FEASIBILITY STUDY ON THE
PROPOSED DRAINAGE DITCH RELOCATION
AT SUNRAY SERVICES SITE 3
TONTITOWN, ARKANSAS

Re: Drainage Ditch Modification, Sunray site 3.

Recently, Sunray Services, Inc. encountered pre-existing trash south of station 7+00 in the area where the approved (May, 1989) western drainage ditch was to be excavated. Sunray Services, Inc. is requesting that a minor permit modification be granted by ADPC&E regarding the western drainage ditch at Sunray site 3.

LANDFILL CROSS-SECTIONS

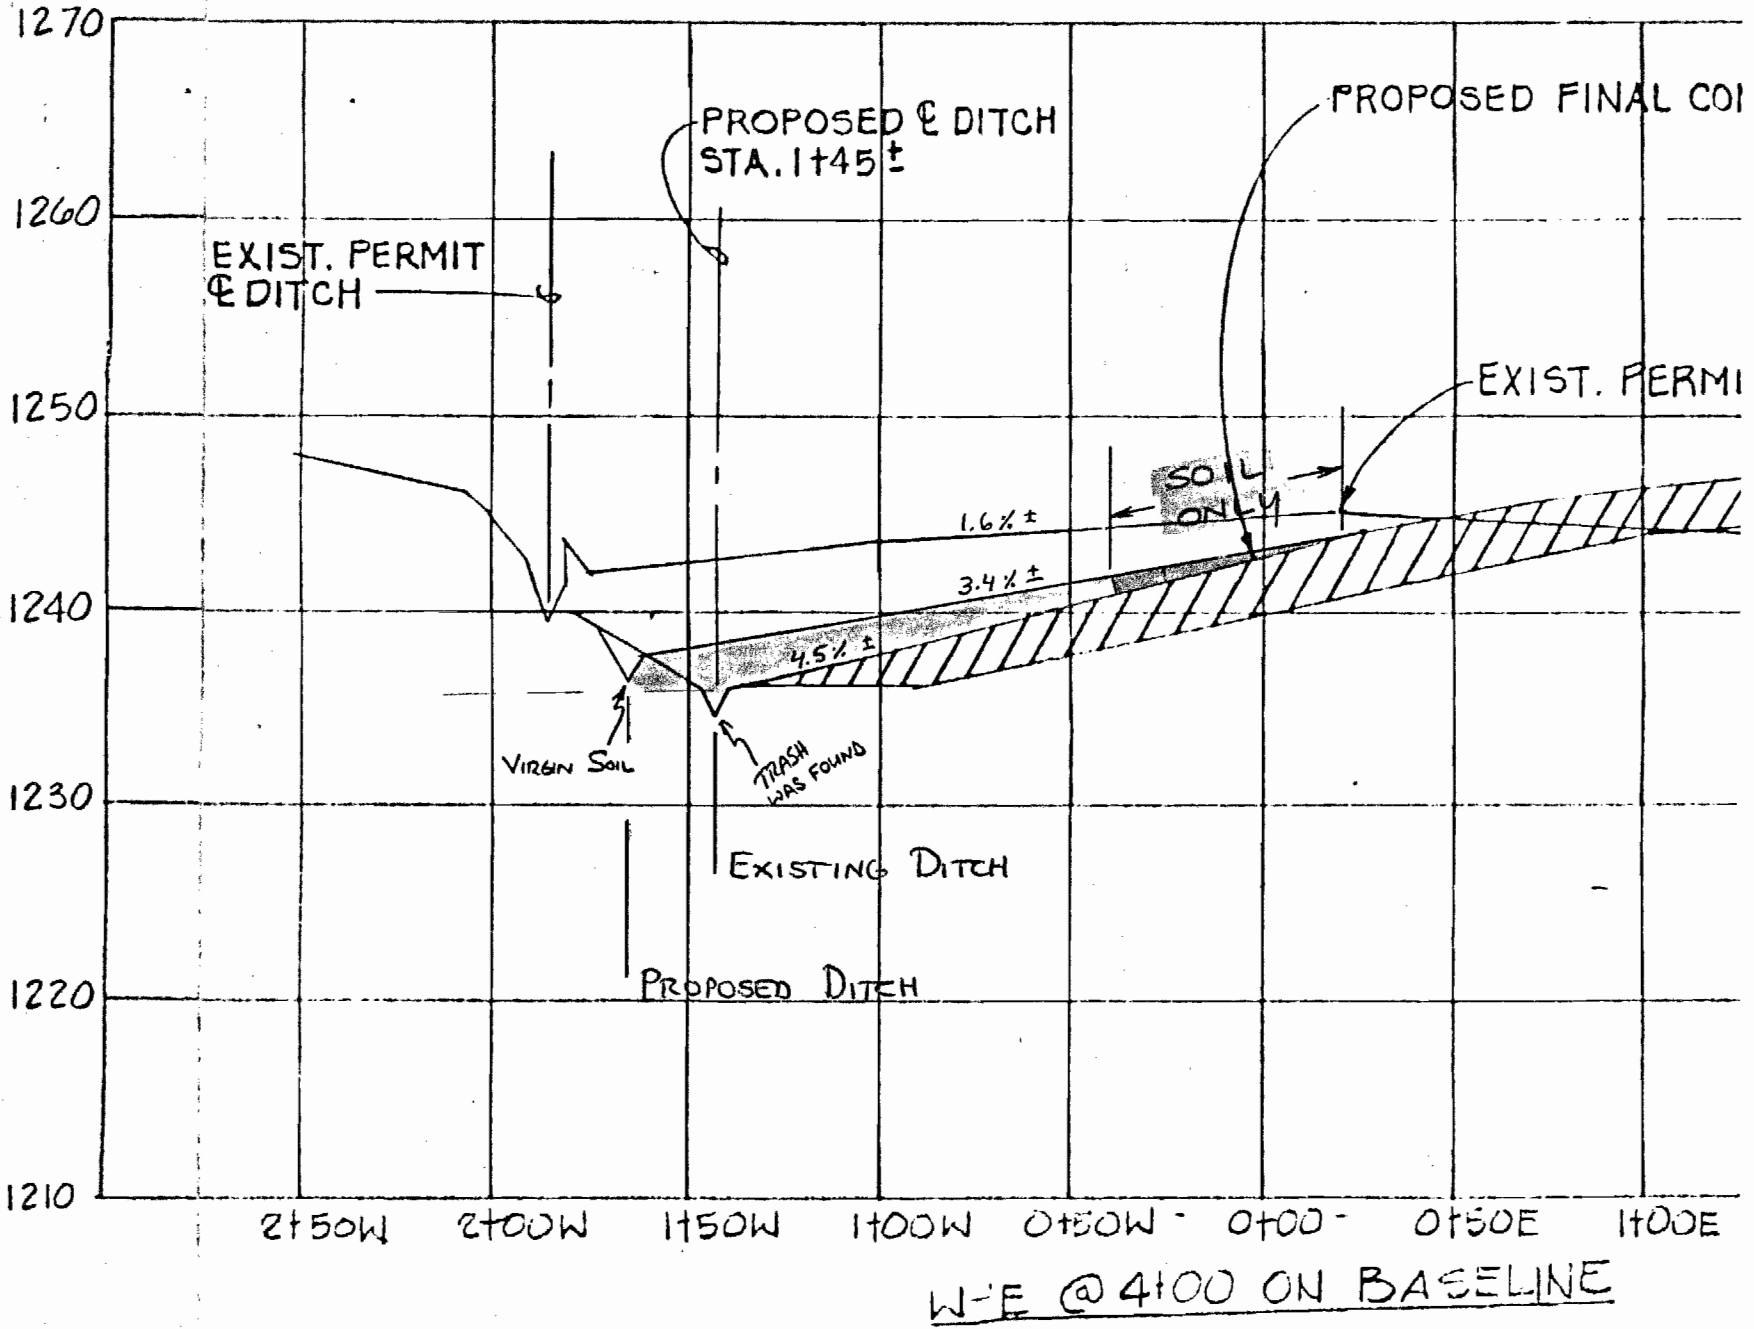
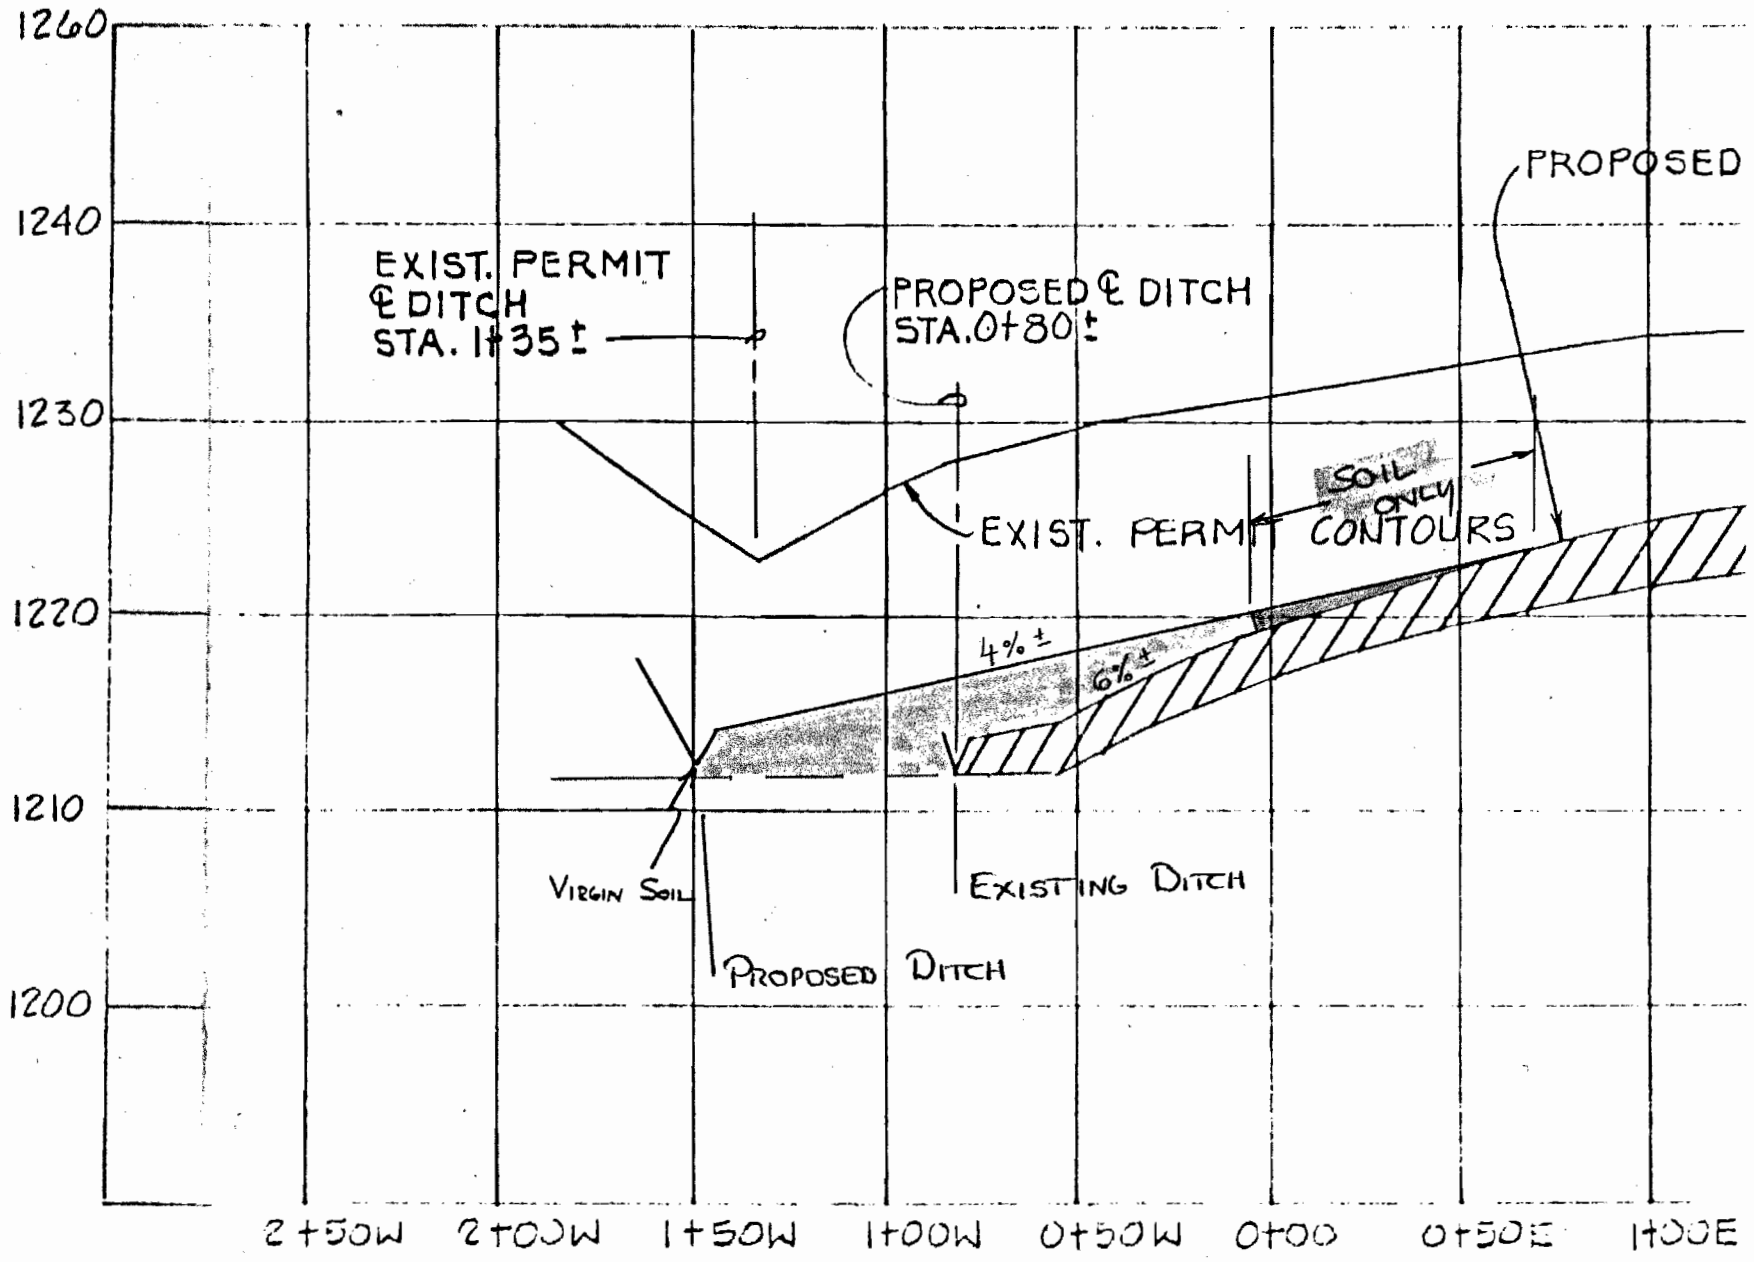
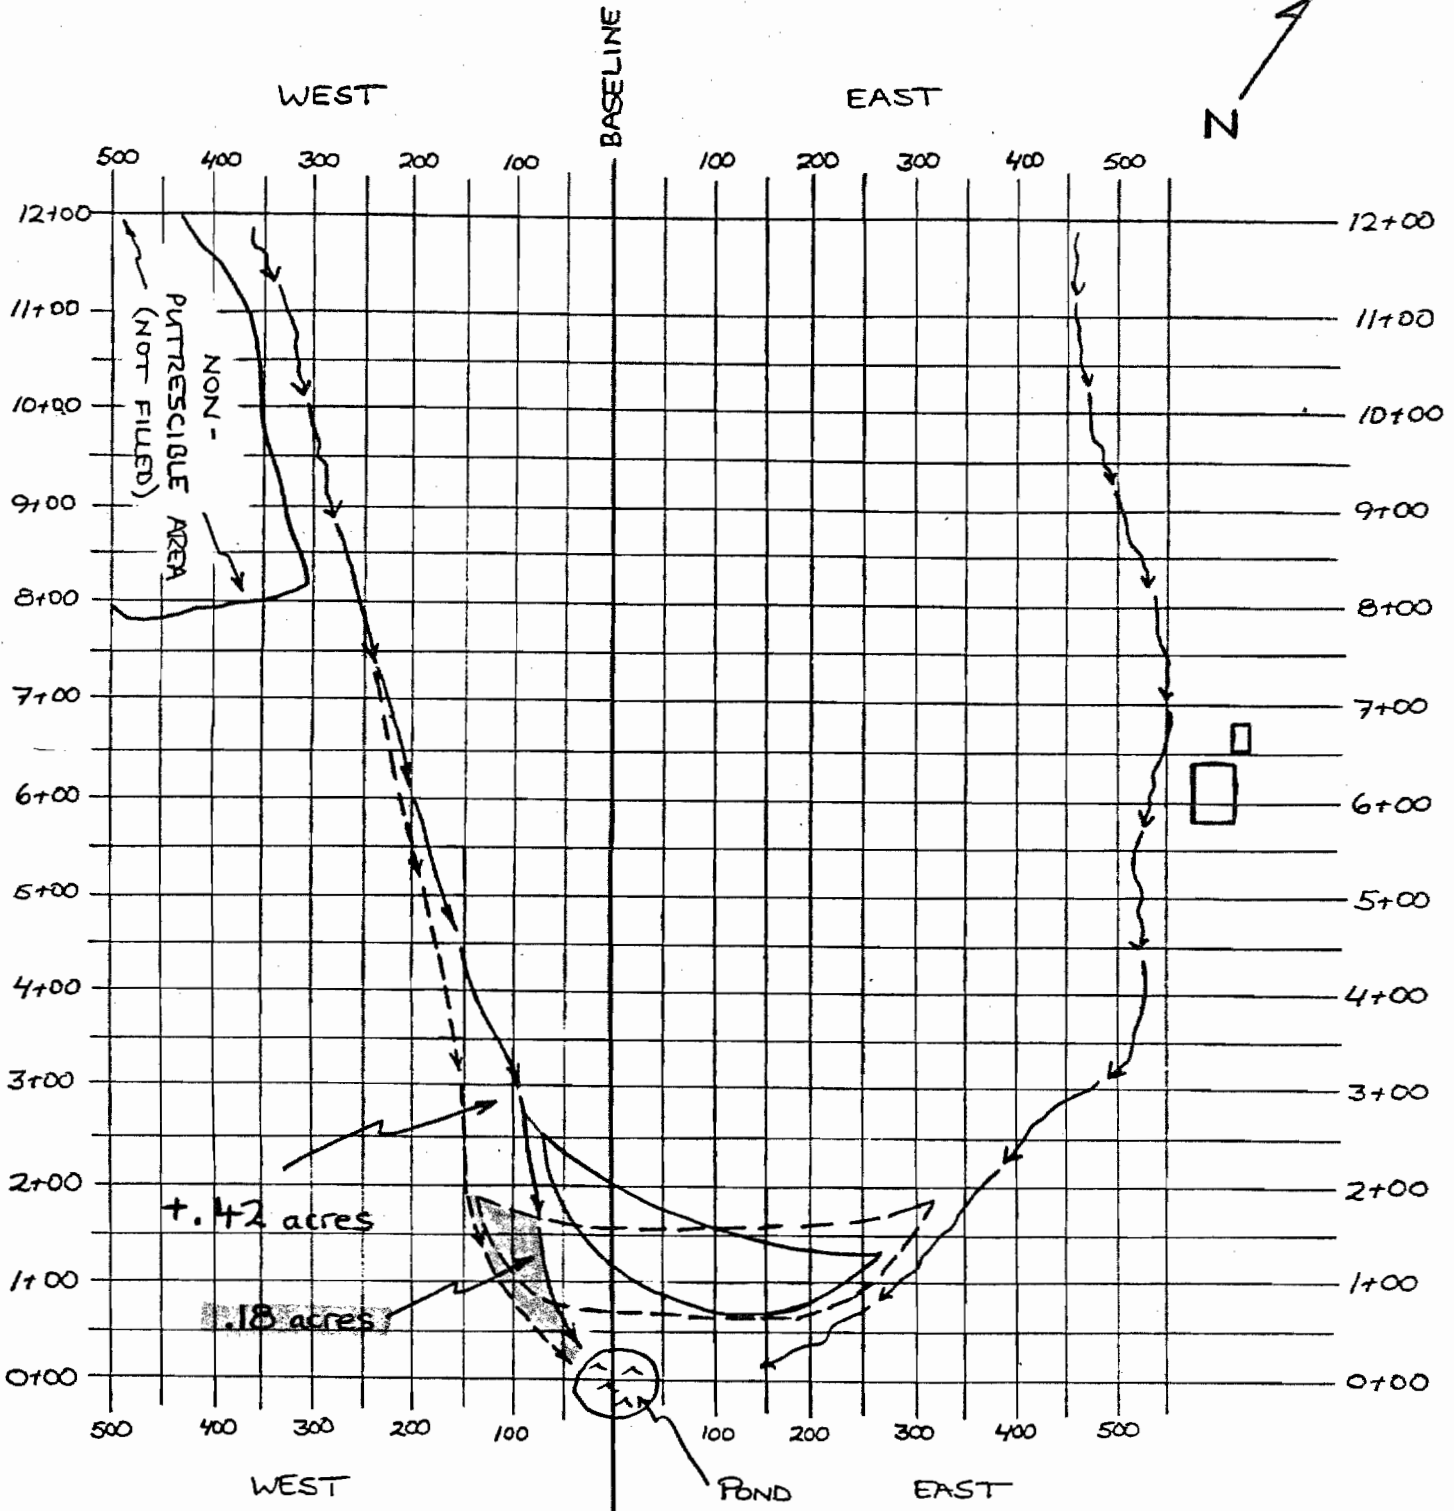
The western slopes south of station 7+50 would be decreased by ~1 percent, in order to reach the proposed drainage ditch location, as shown in Appendix A. As mentioned, the proposed modification would increase the lateral extent of the landfill by ~0.60 acres; approximately 0.42 acres would receive additional trash (see Sheet 1).

The above reduction in slopes would create additional air-space over existing slopes and in the 0.42 acre expansion, as shown in Appendix A. Voids ≤ 1 foot would occur over an area of ~0.78 acres (see Sheet 2) and would be filled in with soil only. All remaining voids (≥ 1 foot) would occur over

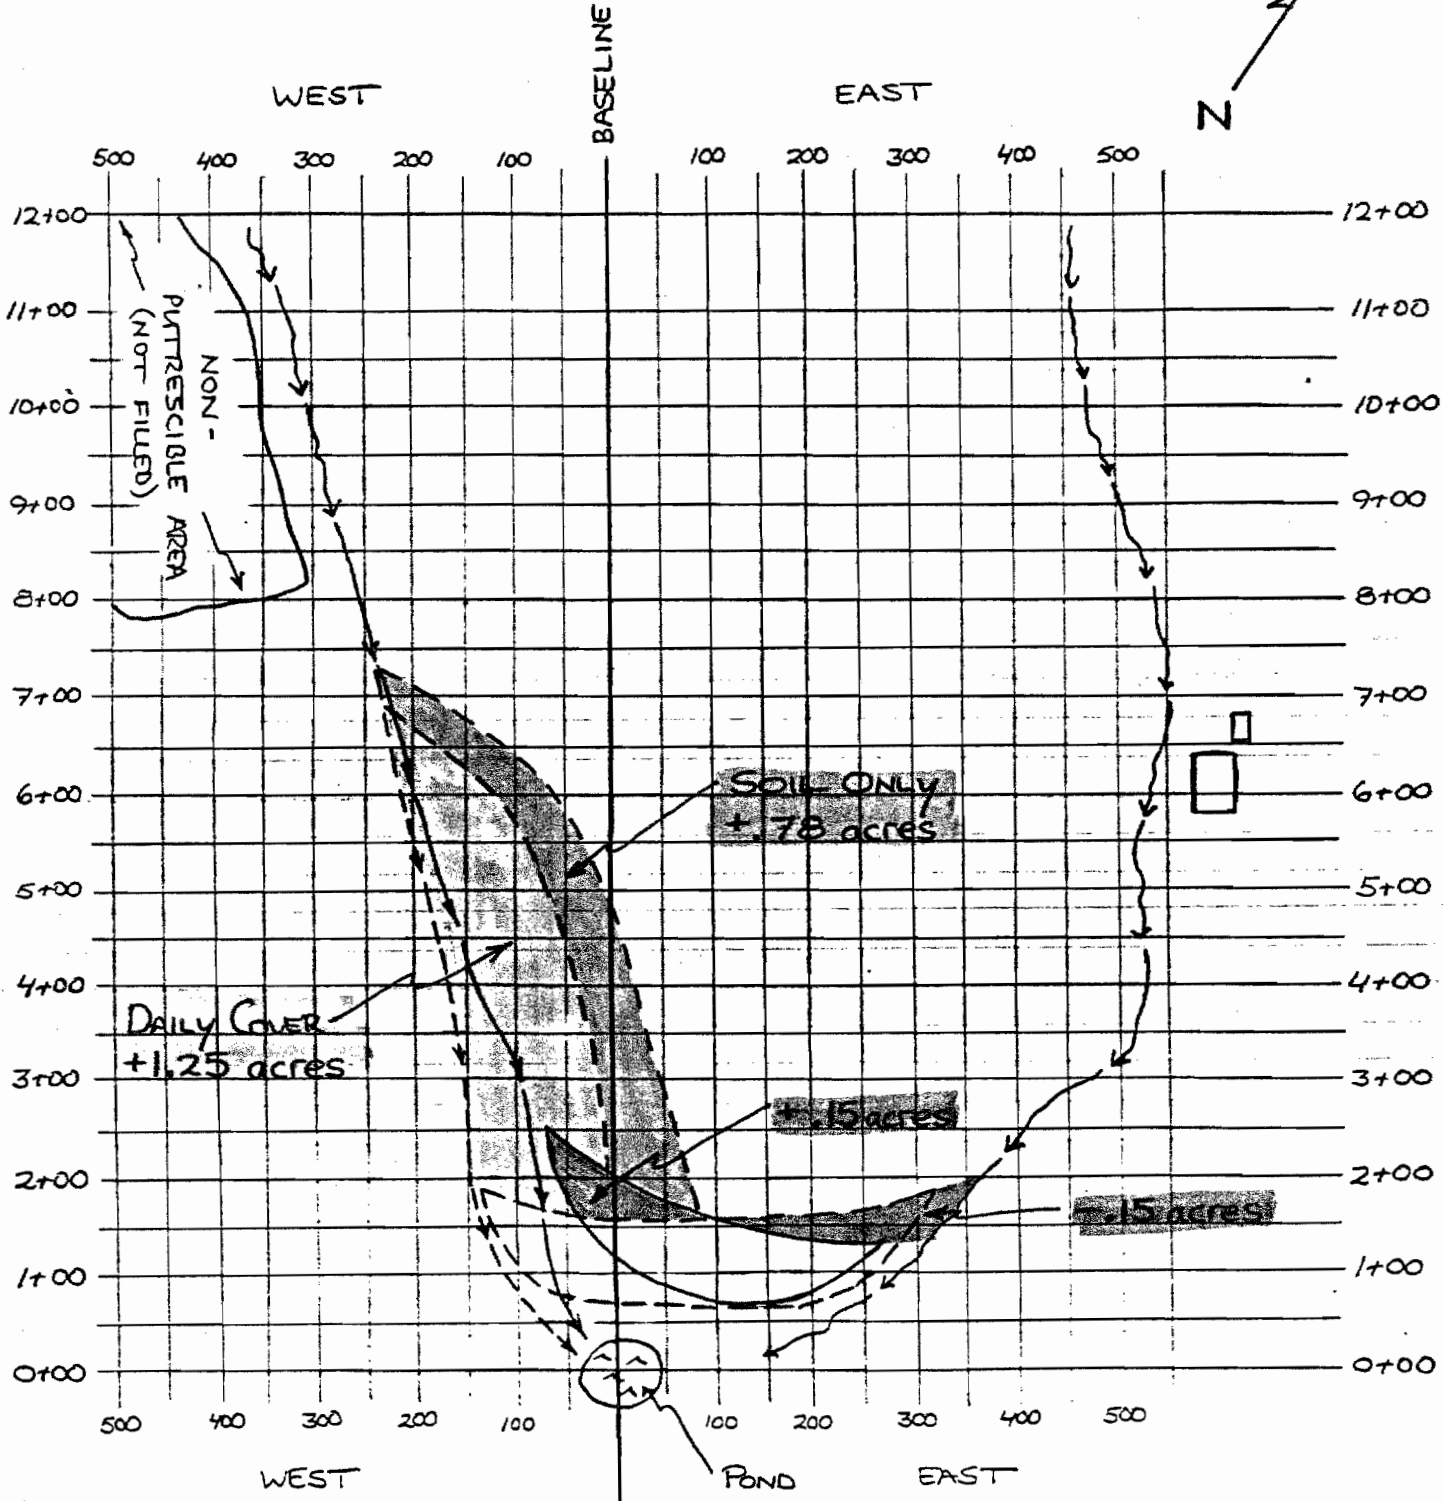
The requested modification involves relocation of the southernmost 700 feet of the western drainage ditch to an area immediately west of the presently approved location (see Sheet 1). Kevin Hodges, Engineer for Sunray Services, Inc. has determined from field observations that the proposed location (between the Class I and Class IV landfills) consists only of virgin soil. A maximum westward shift of 70 feet would be made, increasing the landfill area approximately 0.60 acres, as shown on Sheet 1.

Approximately 0.42 acres (see Sheet 1) would require an additional 2.5 foot thick final cover, which is equivalent to 1,694 CY.
